AGENDA
City of Gig Harbor Design Review Board
Virtual Meeting of May 13, 2021 at 5:00 pm

- 1. **Low Impact Ventures, 4810 Point Fosdick Dr. PMB 60, Gig Harbor, WA 98335: Pioneer Way Mixed Use Development:** (PL-SPR-19-0006, PL-DR-19-0048, PL-ALP-19-0004, and PL-SEPA-19-0008) The project proposal consists of two mixed use, low impact development buildings on a site

**COMMUNITY DEVELOPMENT DEPARTMENT
PLANNING DIVISION
SUPPLEMENTAL STAFF REPORT**

Re: Design Review Response, No. 2
Pioneer Way Mixed Use Development
Per: PL-SPR-19-0006, PL-ALP-19-0004, PL-DR-19-0048, PL-SEPA-19-0008

2. GHMC17.99.380 (A) avoid long low wall planes, and (D) provide visual terminus to tops of buildings

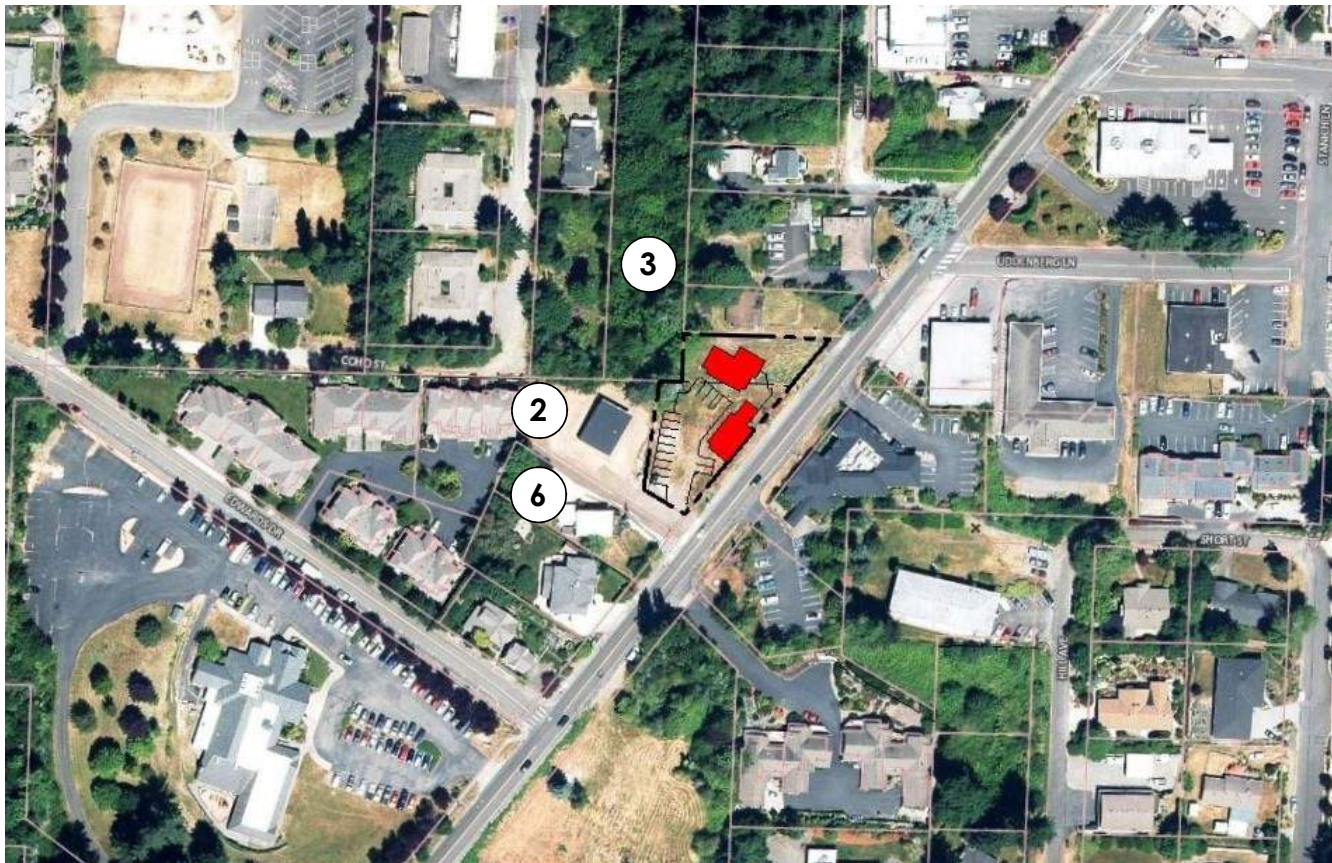
The DRB indicated that the applicant's proposed lower roof slope of 3/12, and upper roof slope of 6/12 meets the intent of the code.

BUILDING SECTION SHOWING ROOF SLOPES

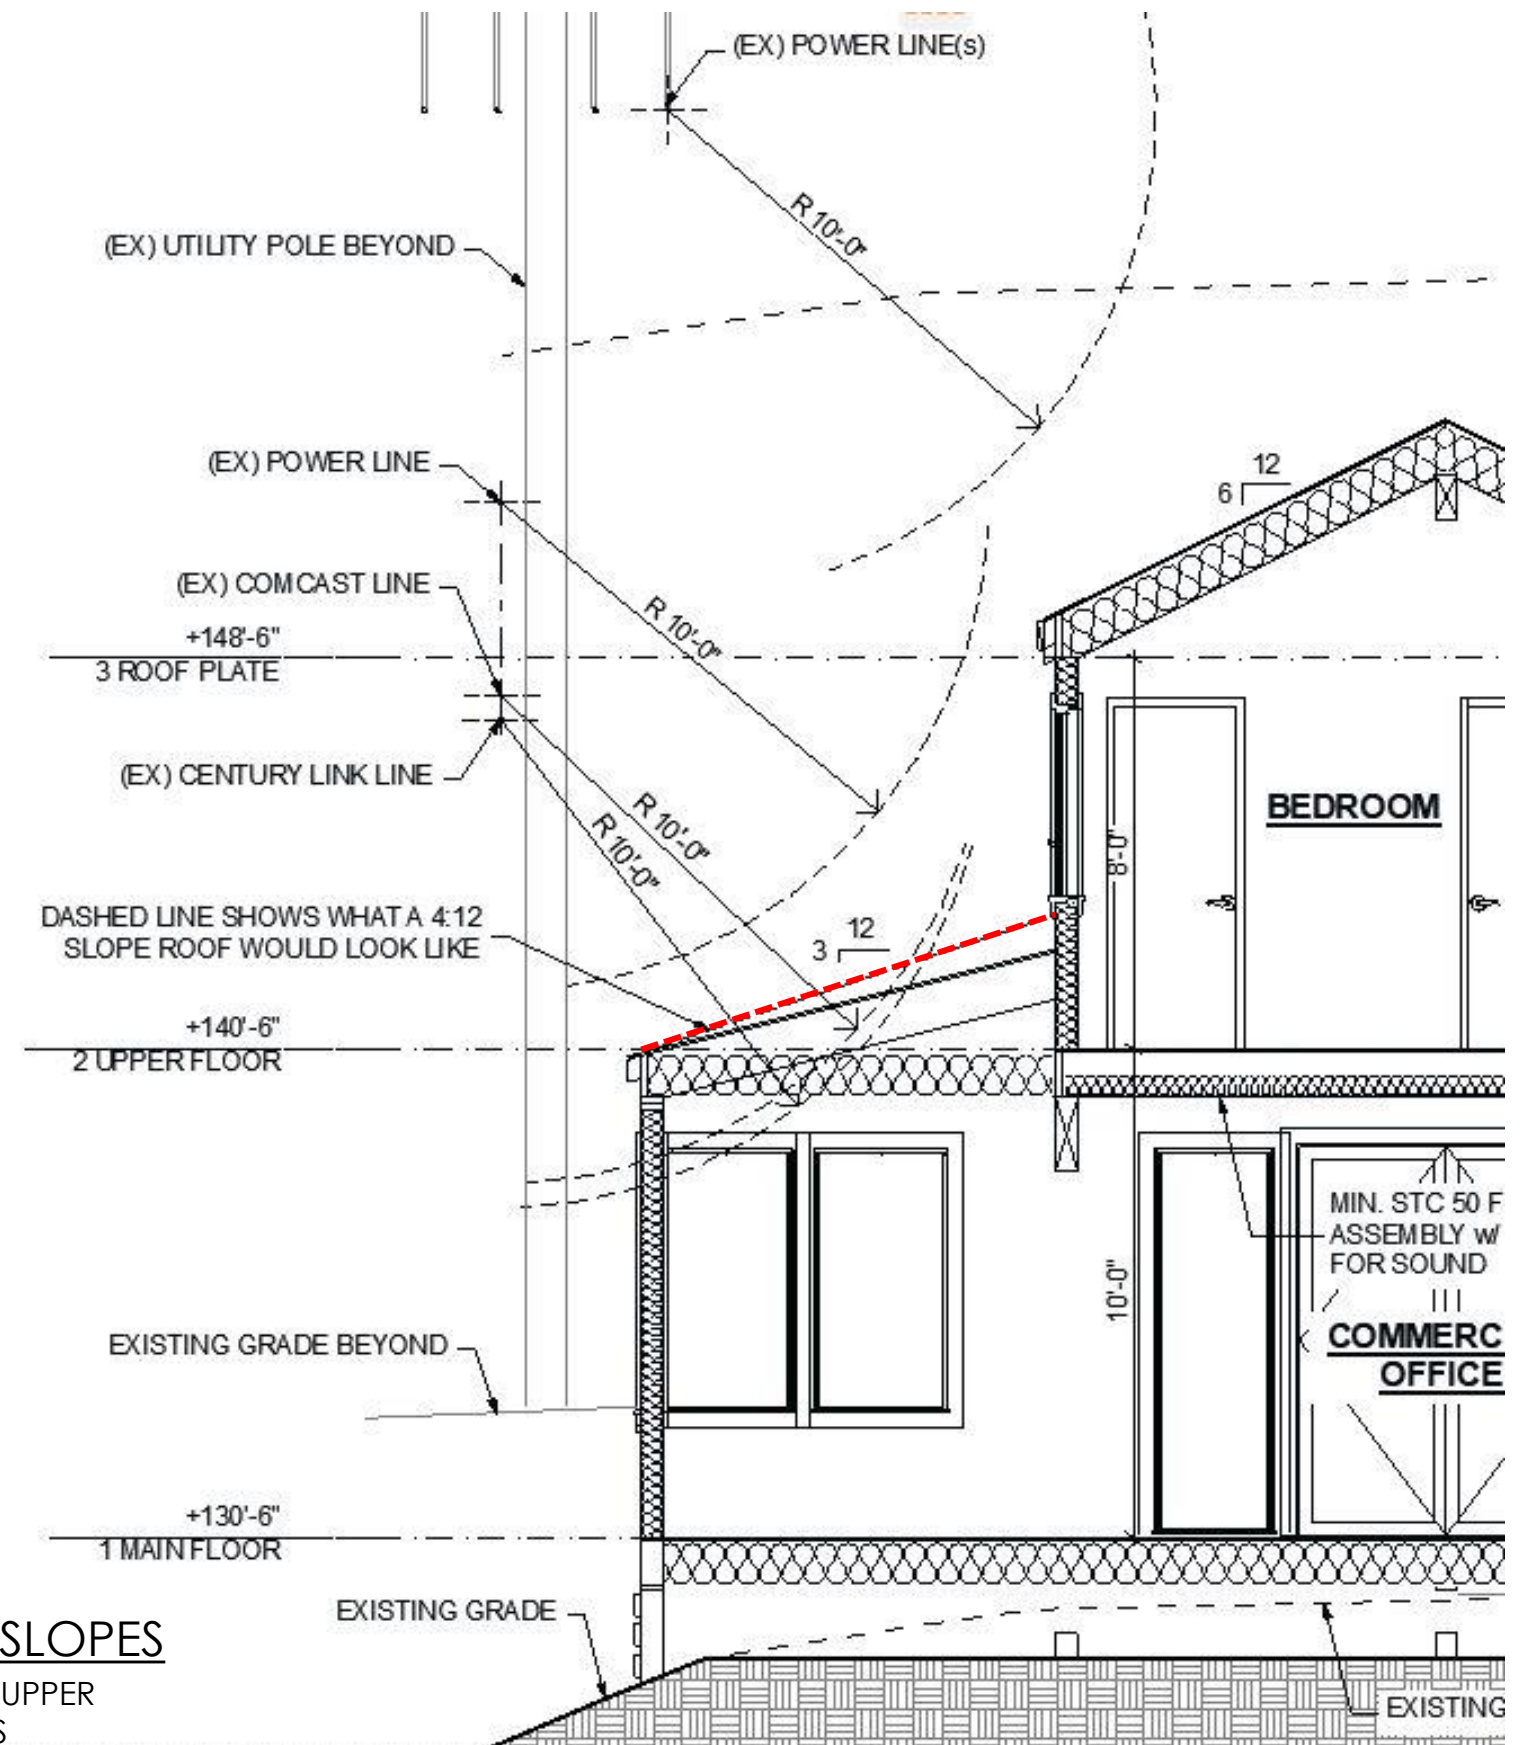
- LOWER ROOFS NEED TO BE 3:12 SLOPE TO ALLOW UPPER FLOOR WINDOWS TO MEET EGRESS REQUIREMENTS

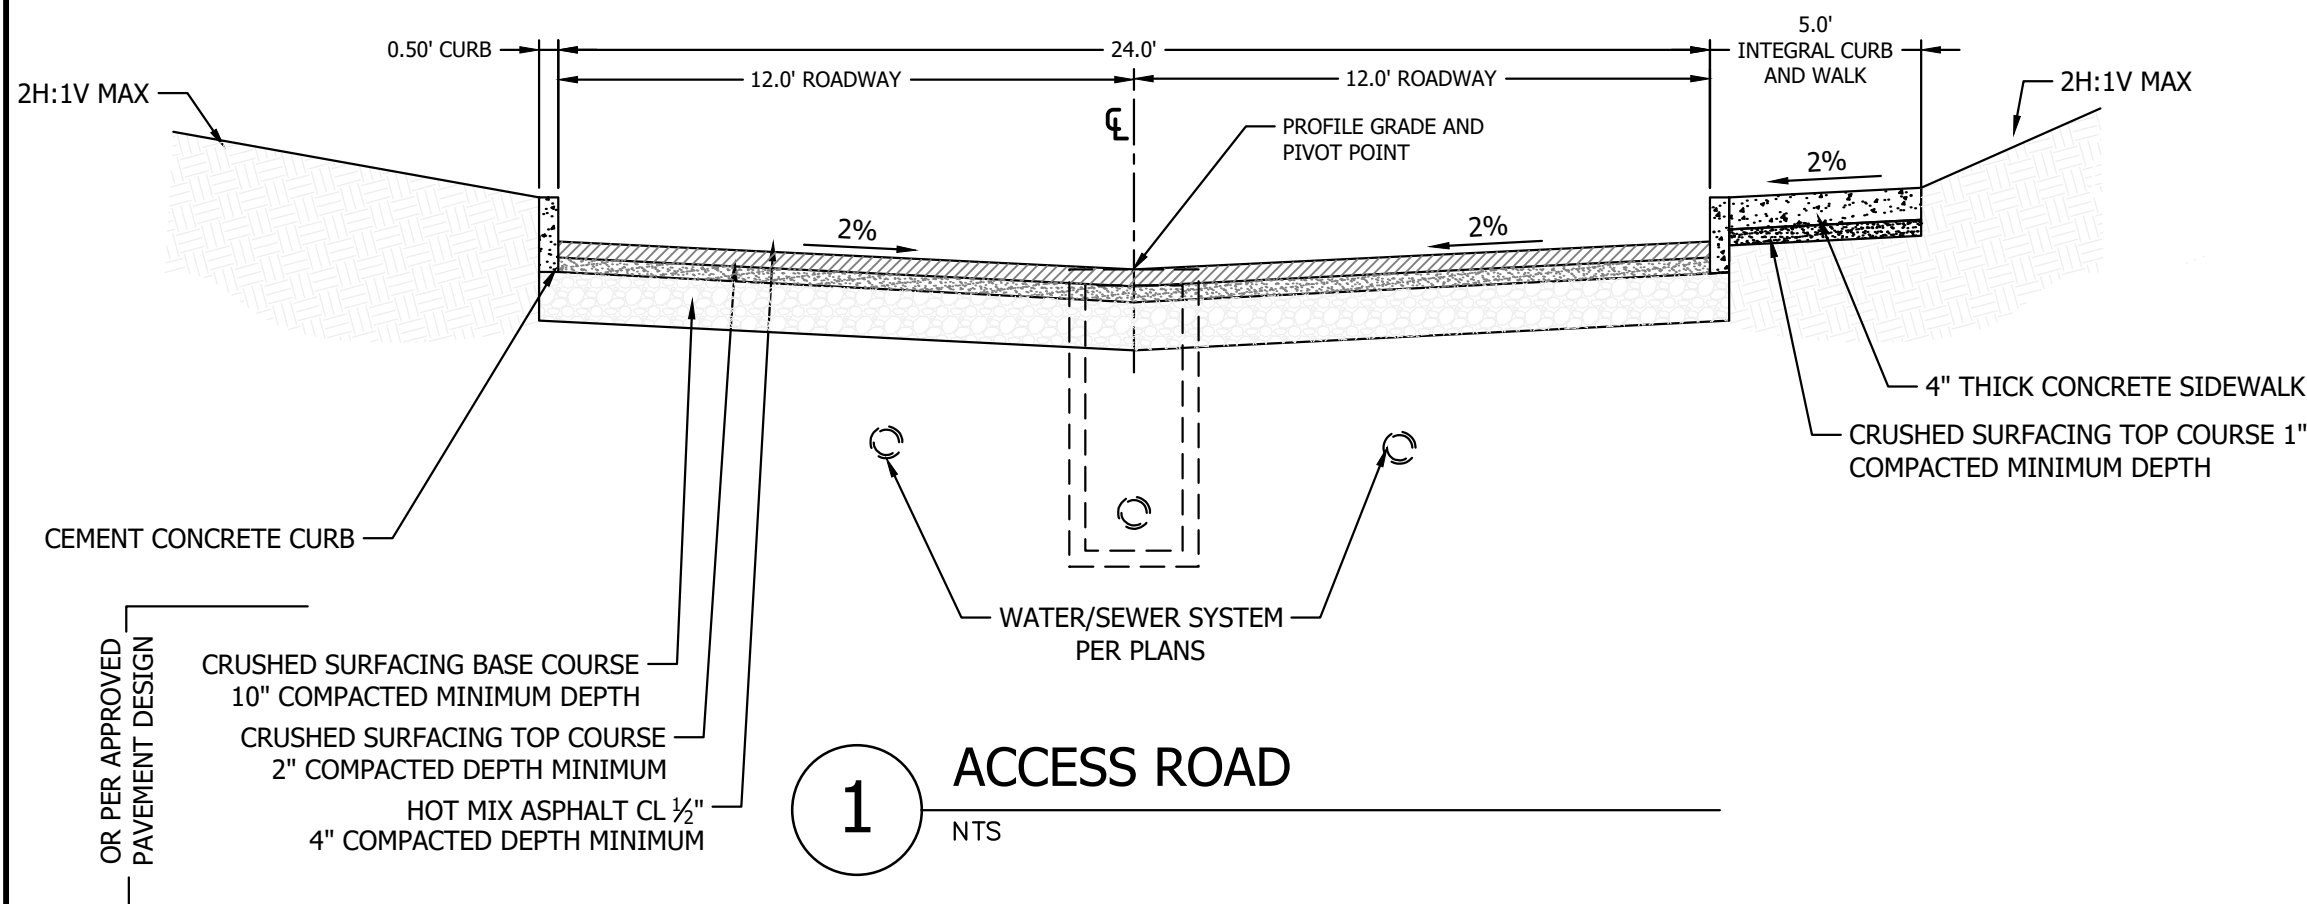
- A 14% difference in cut and fill quantities, as represented on sheet C3 of Exhibit B;
 - An increased difference in cut and fill quantities of up to 20%, provided that the current site design incorporating a "stepped" building (Building B) and lower-level parking garage is maintained, and further provided that the increase in grading does not result in a change to the finish floor elevations presently designed in Exhibit B.

1,900/13,850 = 14% - CUT/FILL QUANTITIES TO BE REVIEWED BY DRB
